SB-10049739-5741

SI B61 36 12
General Electrical Systems

Service Action: Program Control Units (FEM)

F30

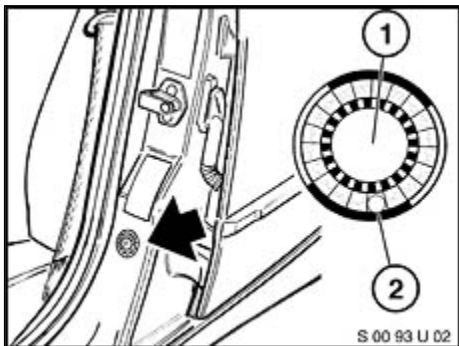
1. Program the vehicle using ISTA/P 2.48.1 or later.

F30 - Integration level (new): F020-12-11-502

Note that ISTA/P will automatically reprogram and code all programmable control modules that do not have the latest software.
